ATTACHMENT 1
PROPOSED APPENDIX A TECHNICAL SPECIFICATION CHANGE
NORTH ANNA POWER STATION UNIT 1

ATTACHMENT 2

PROPOSED APPENDIX B TECHNICAL SPECIFICATION CHANGE

NORTH ANNA POWER STATION UNIT 1

Figure 6.2-2 Facility Organization - North Anna - Units 1 and 2

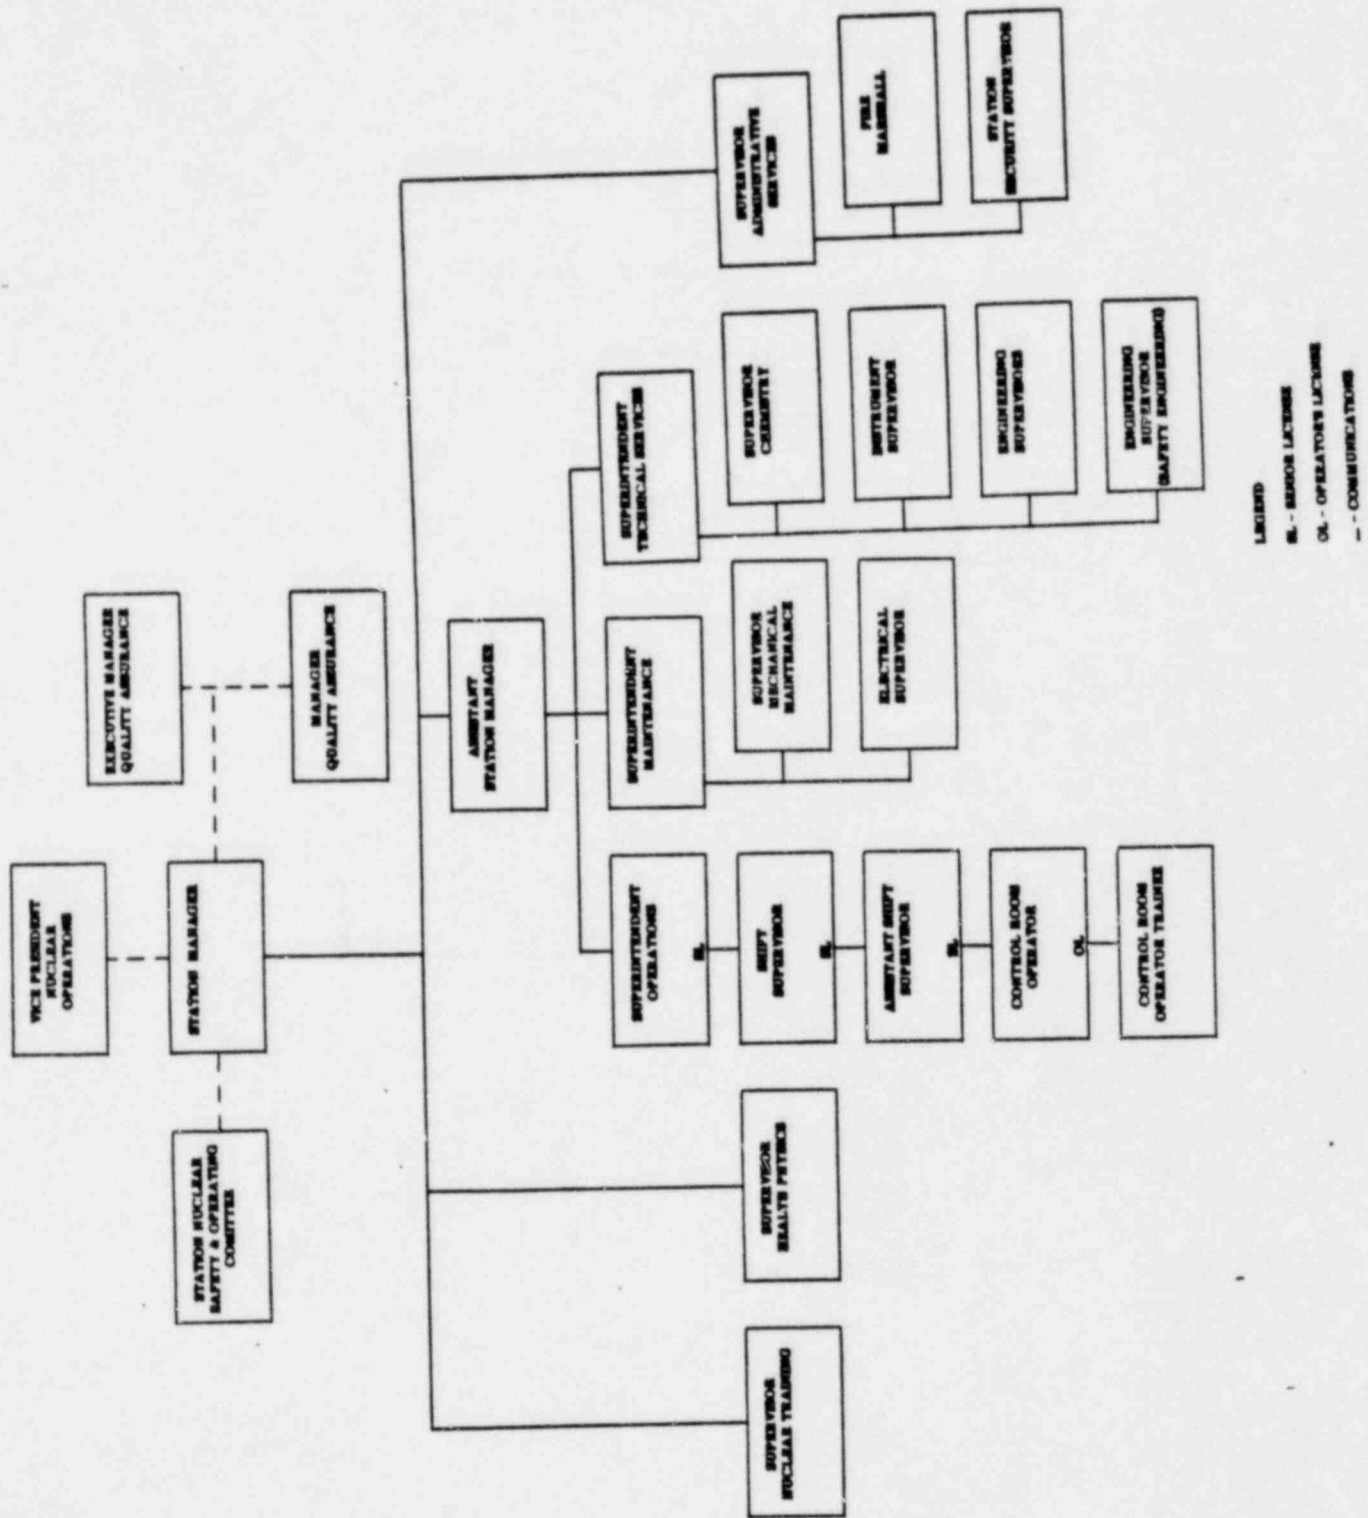
PROPOSED APPENDIX A TECHNICAL SPECIFICATION CHANGE

FIGURE 3.3-1
ORGANIZATION CHART
ENVIRONMENTAL TECH SPEC IMPLEMENTATION

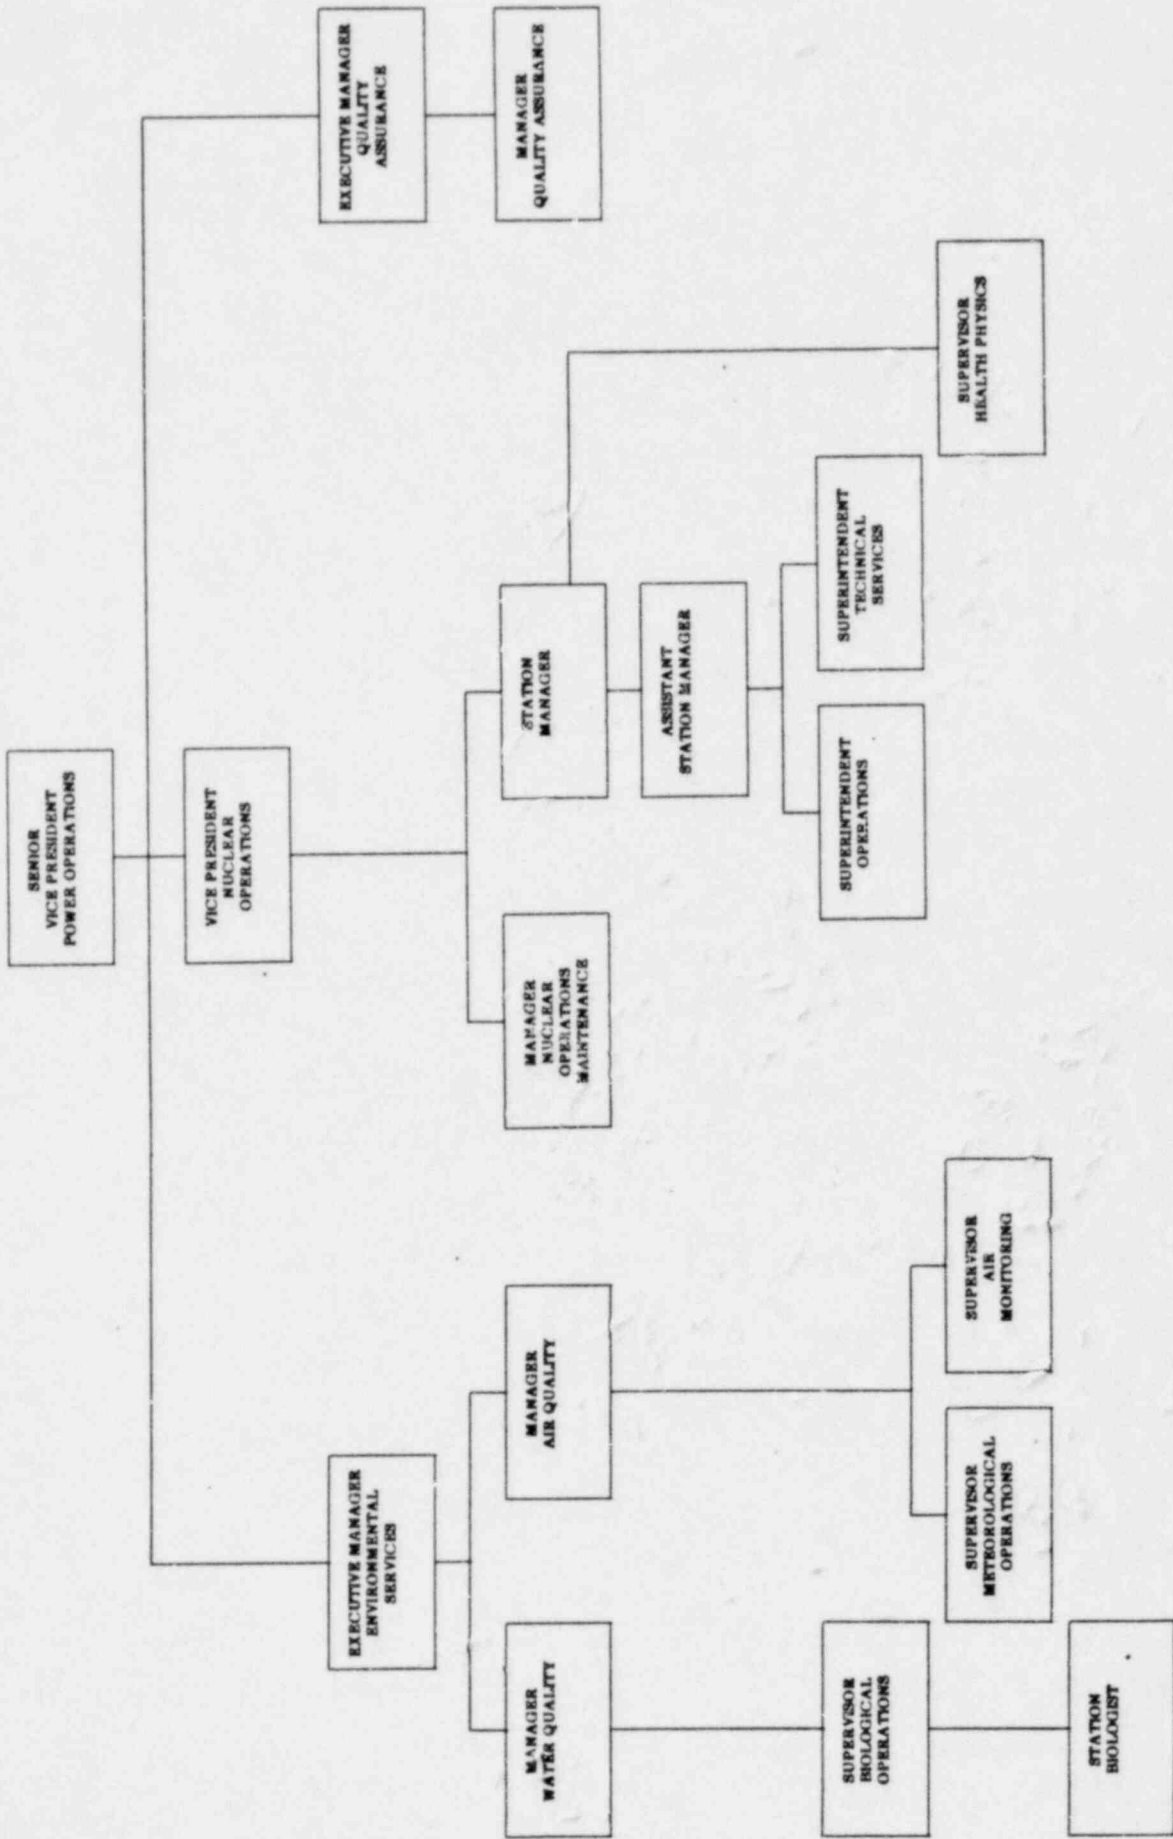
PROPOSED APPENDIX B TECHNICAL SPECIFICATION CHANGE
